"Results of Controlled & Uncontrolled Axial Xenon Oscillation Test" & Change to Tech Specs for H.B. Robinson Unit No. 2

TECHNICAL SPECIFICATION CHANGE REQUEST - PART LENGTH RODS  
FACILITY LICENSE NO. DPR-23  
DOCKET NO. 50-261

ENCLOSURE A  
RESULTS OF CONTROLLED AND UNCONTROLLED  
AXIAL XENON OSCILLATION TEST

ENCLOSURE B

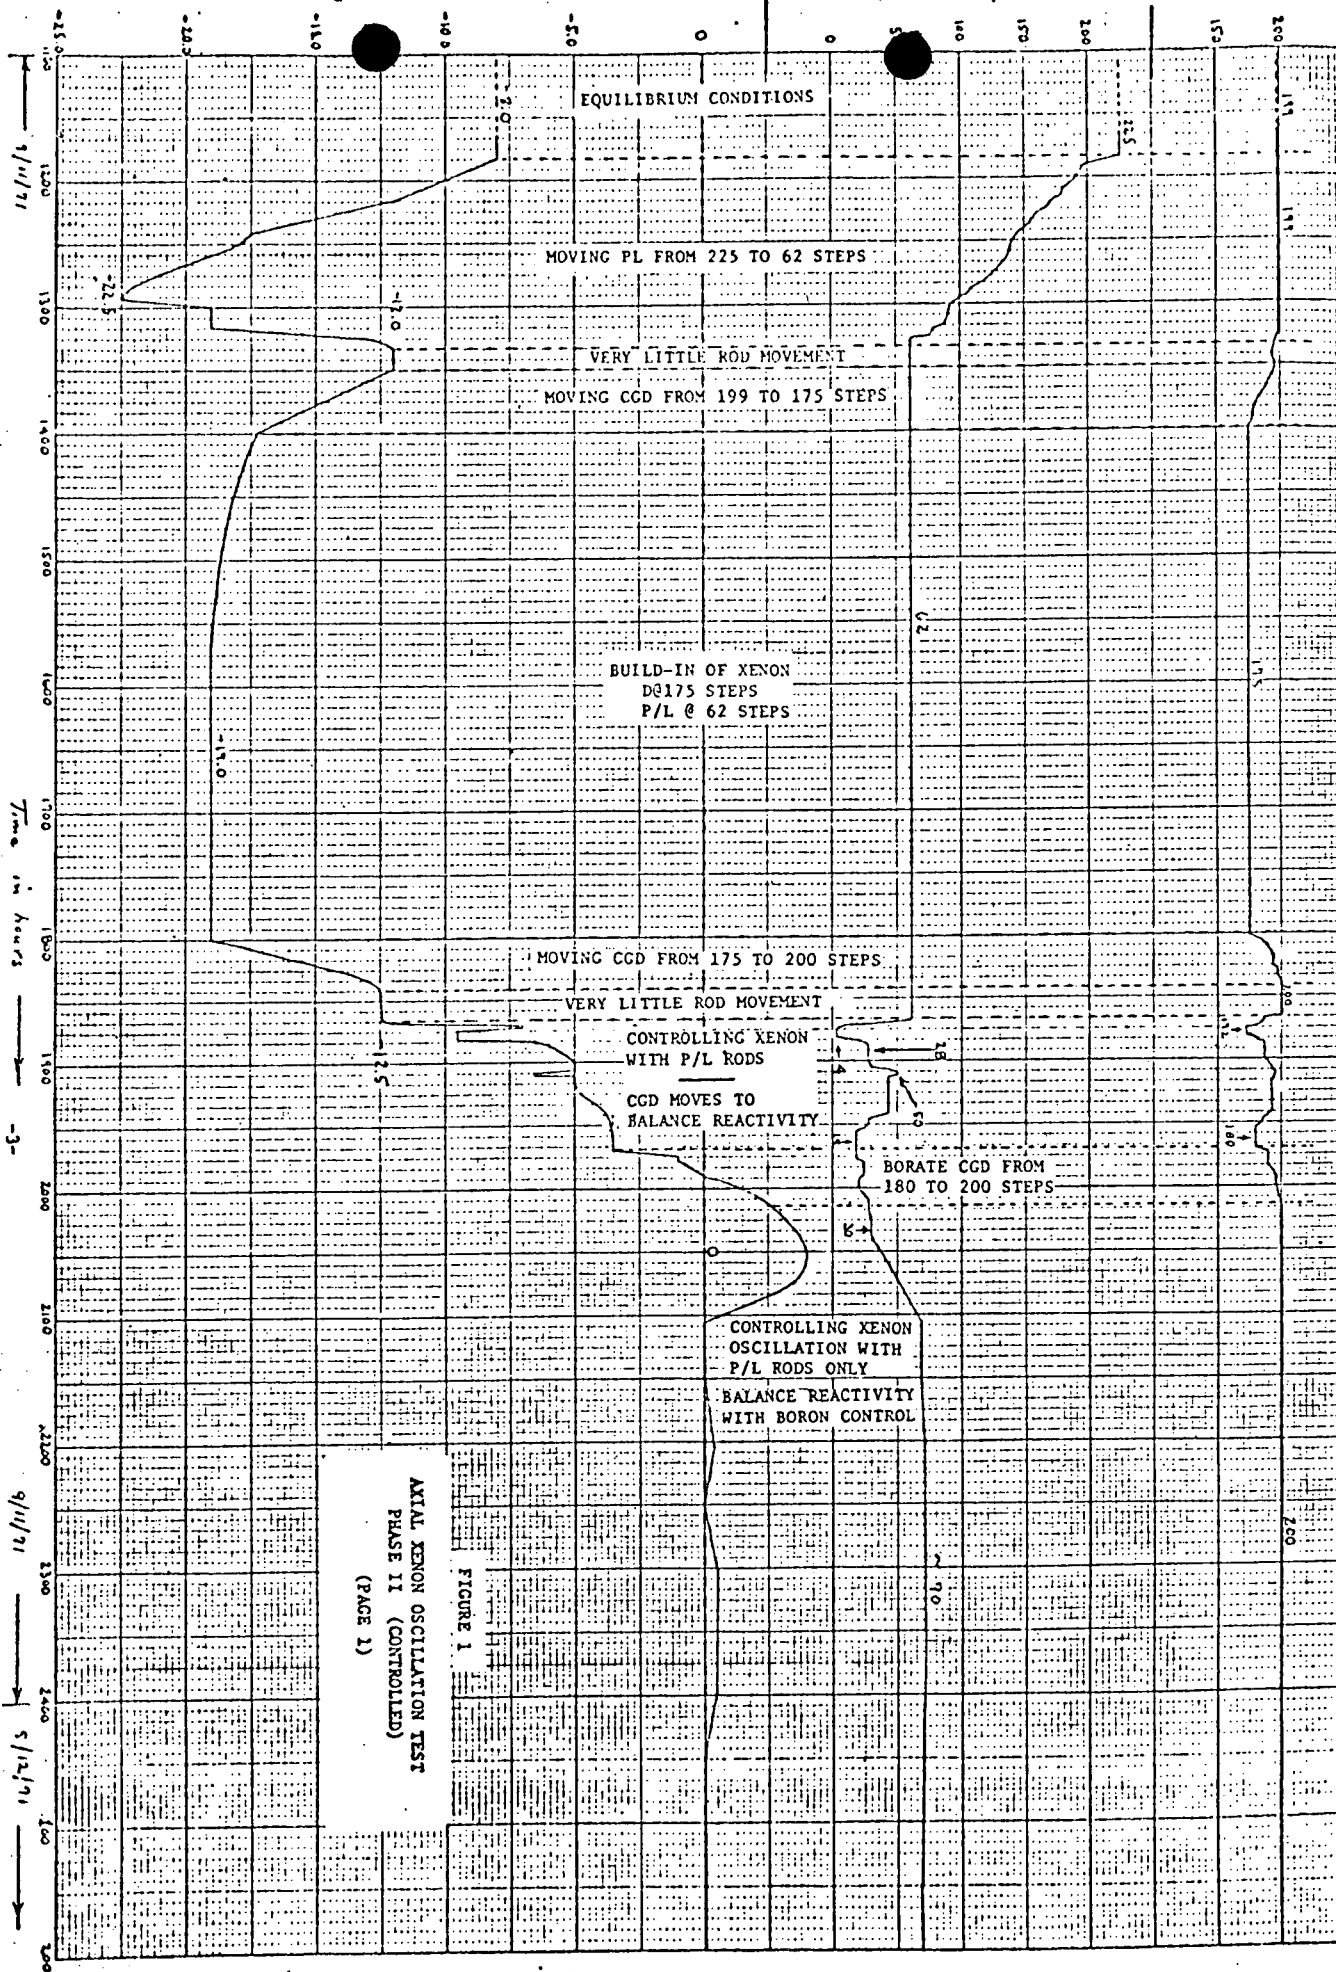
The history of rod positioning and changes in  $I$  during this test is presented by Figures 1 and 2. Based on the response of N44 -  $\Delta I$  meter indication this test demonstrated the ability of the P/L rods to control axial xenon oscillation by maintaining  $\Delta I$  within the specified band of  $\pm 9\%$ .

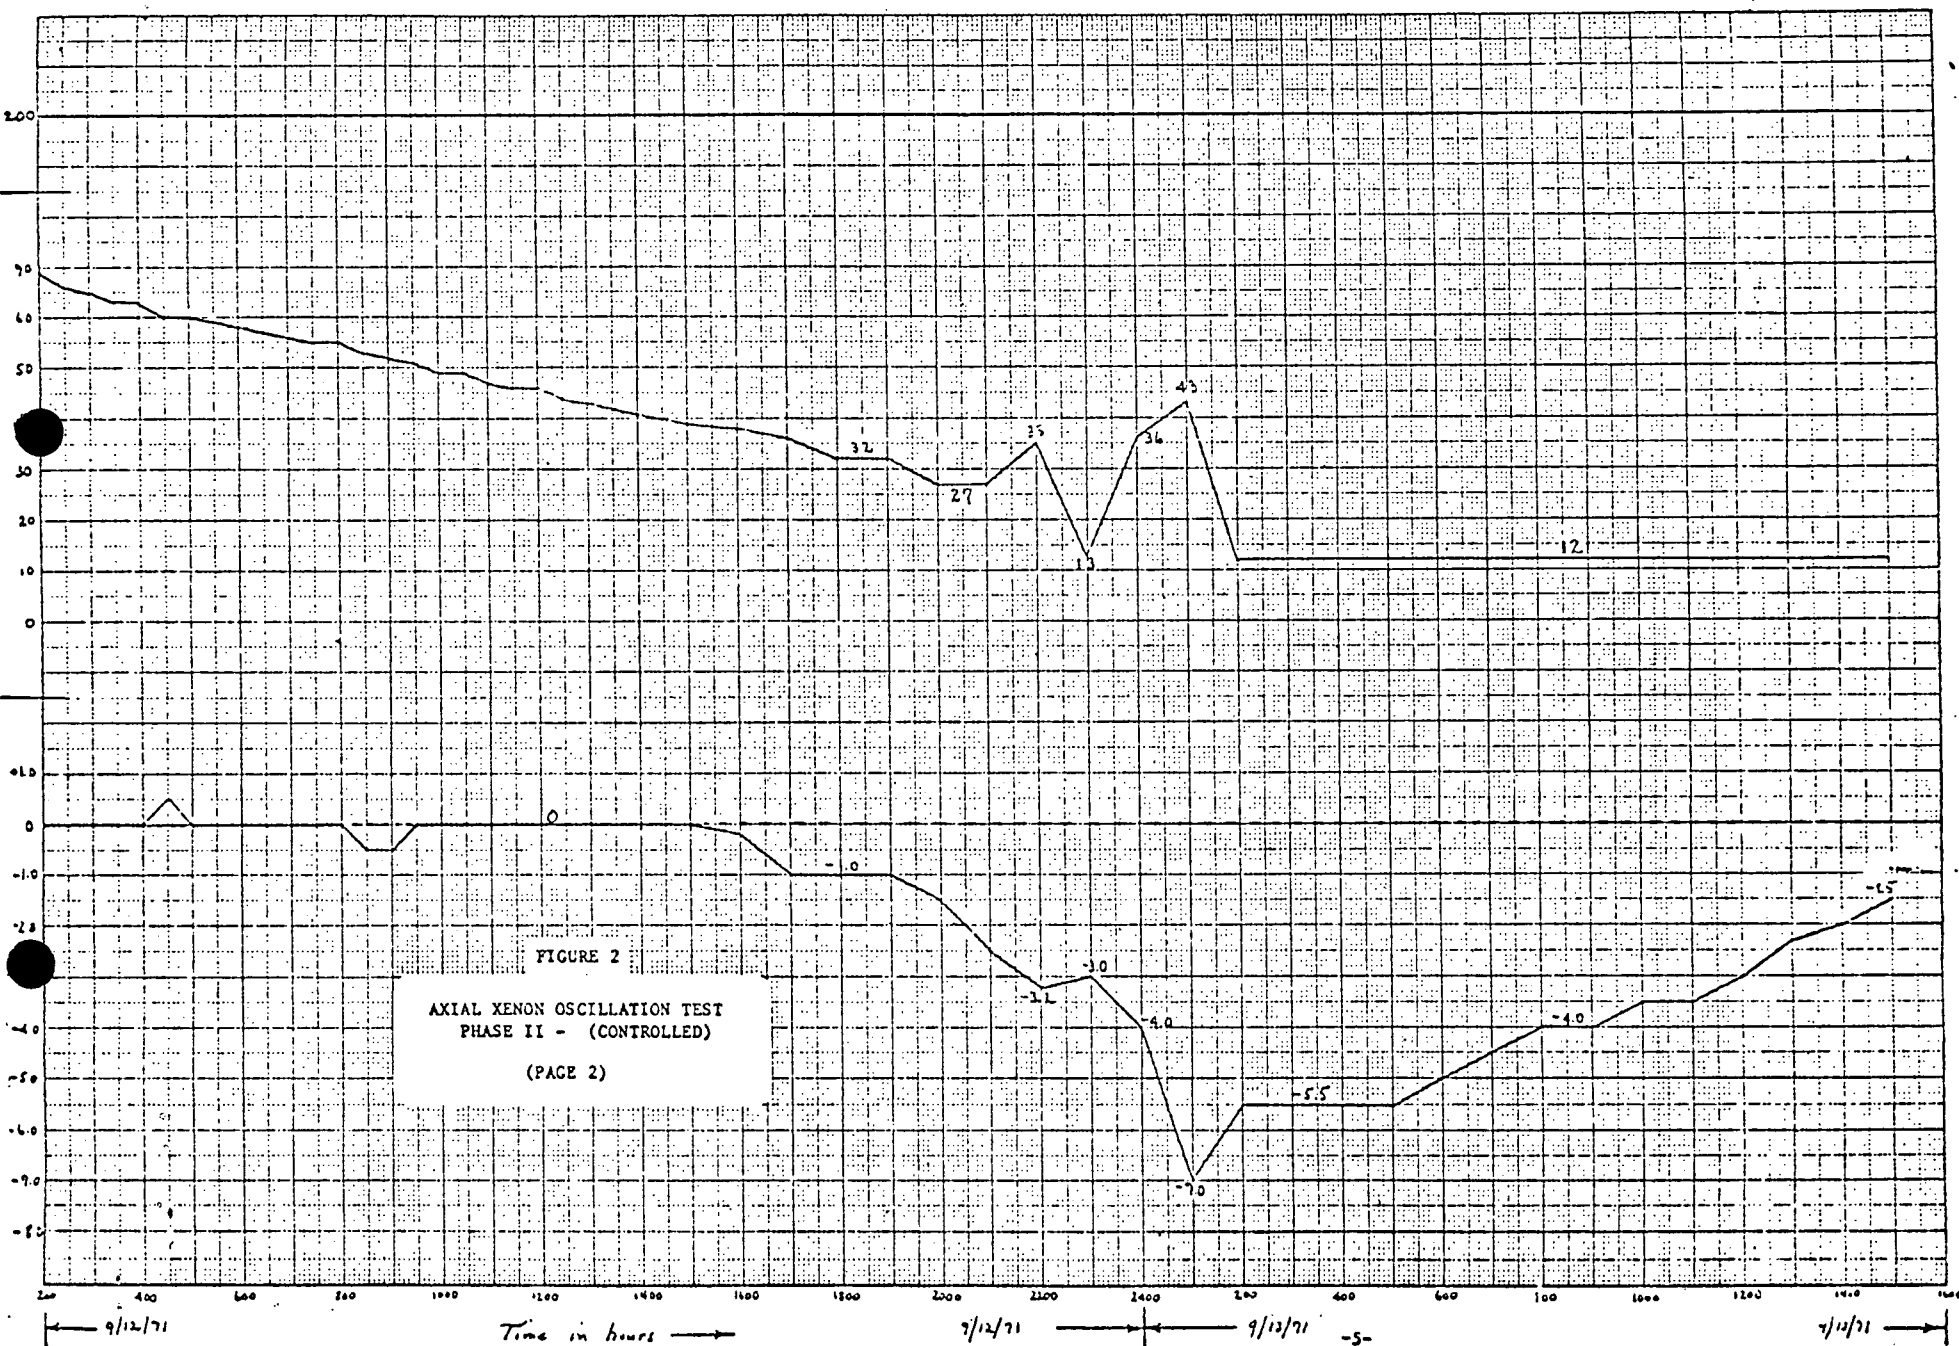
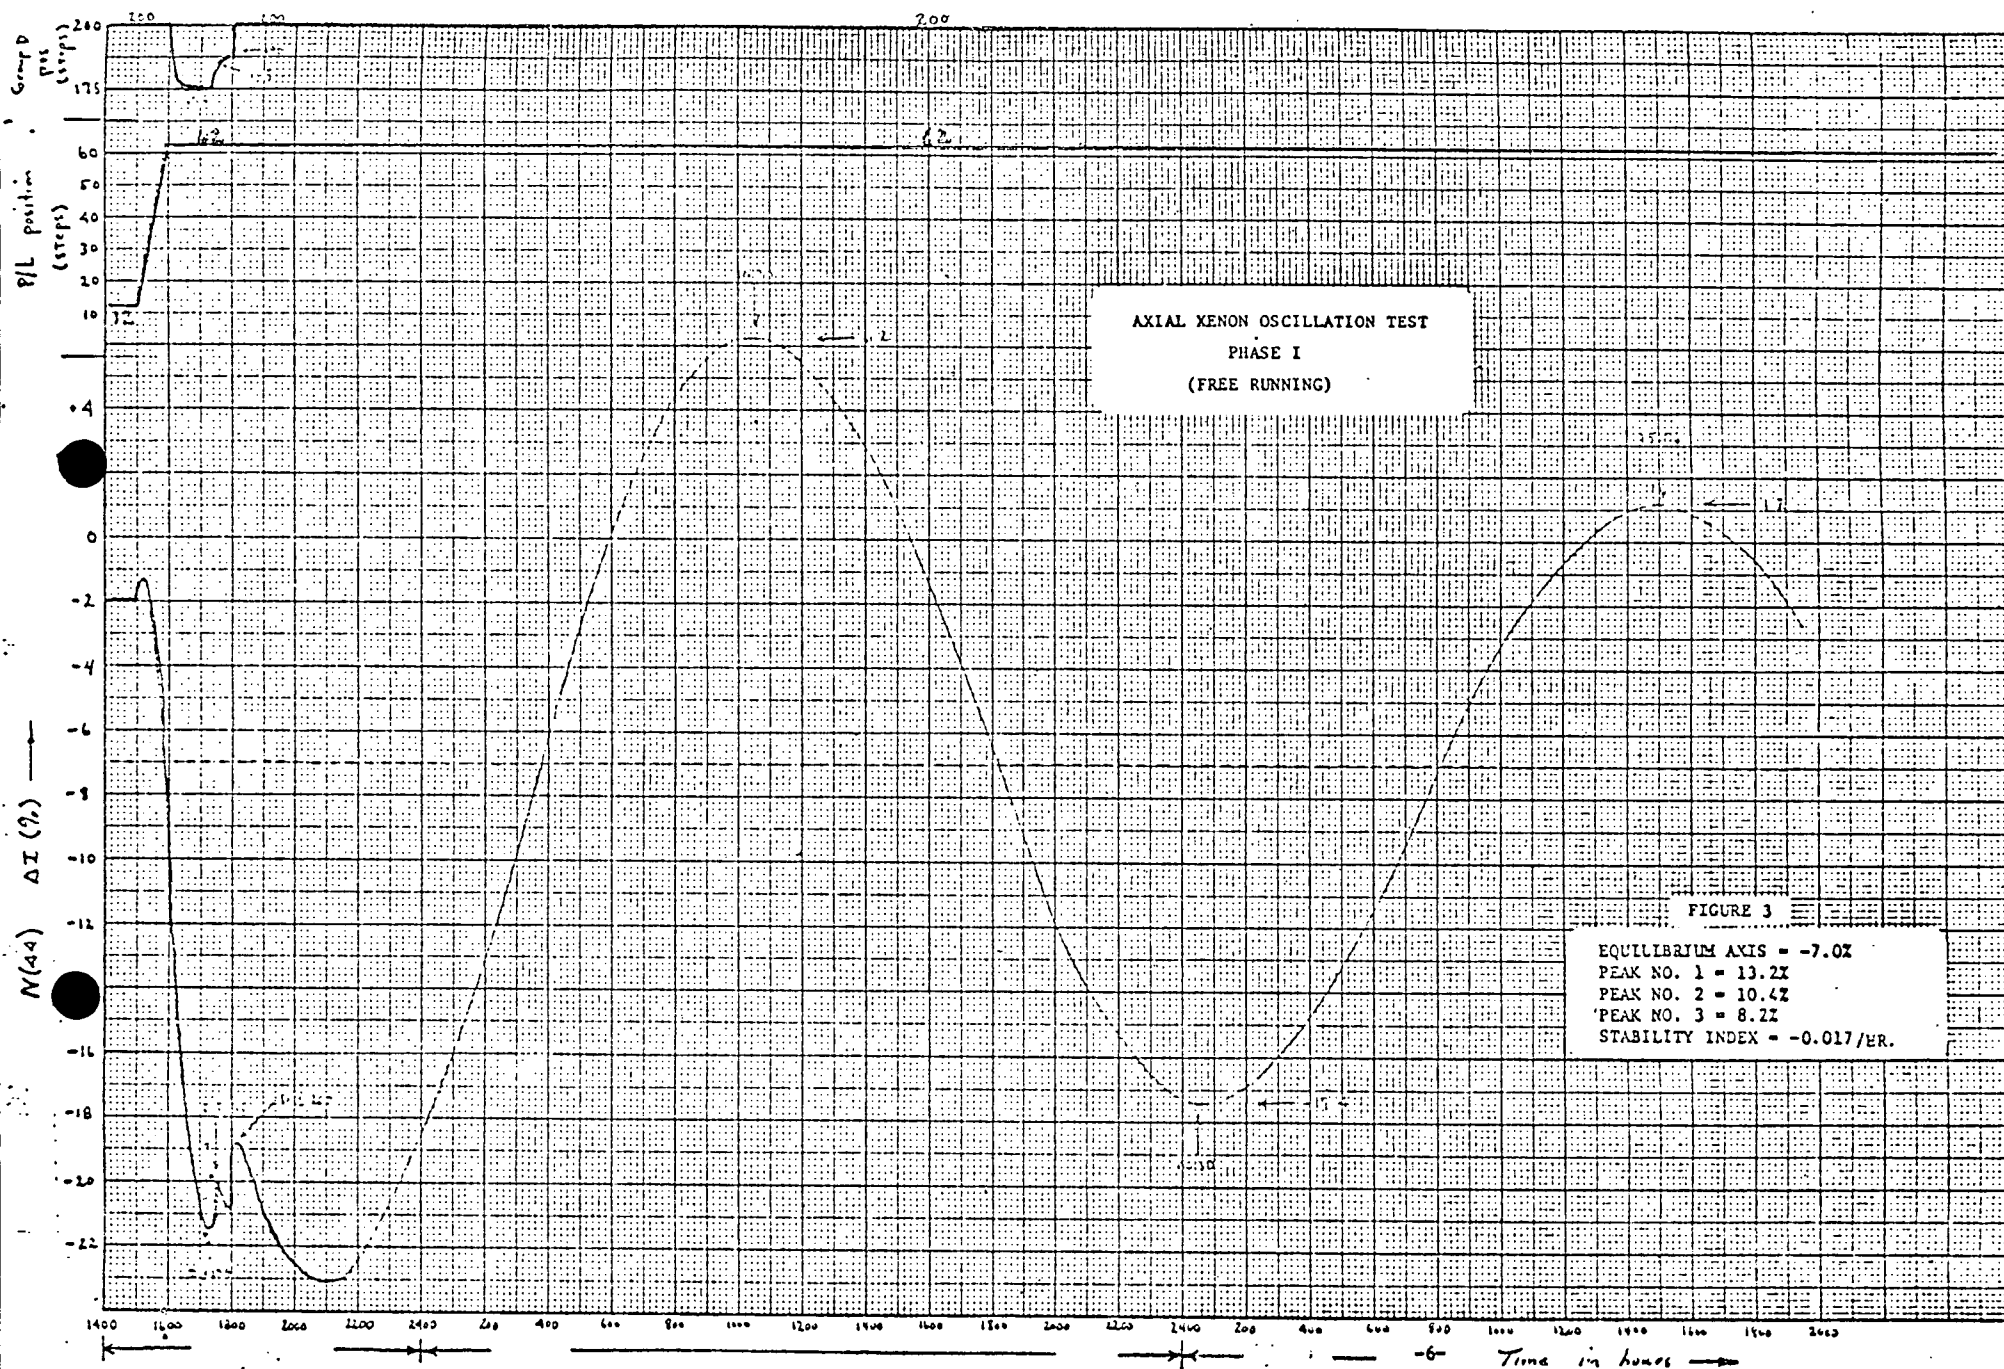
The history of rod positioning and changes in  $\Delta I$  is presented by Figure 3. Based on the response of N44 -  $\Delta I$  meter indication the oscillation was found to be dampened with a stability index of  $-0.017/\text{hr}$ .
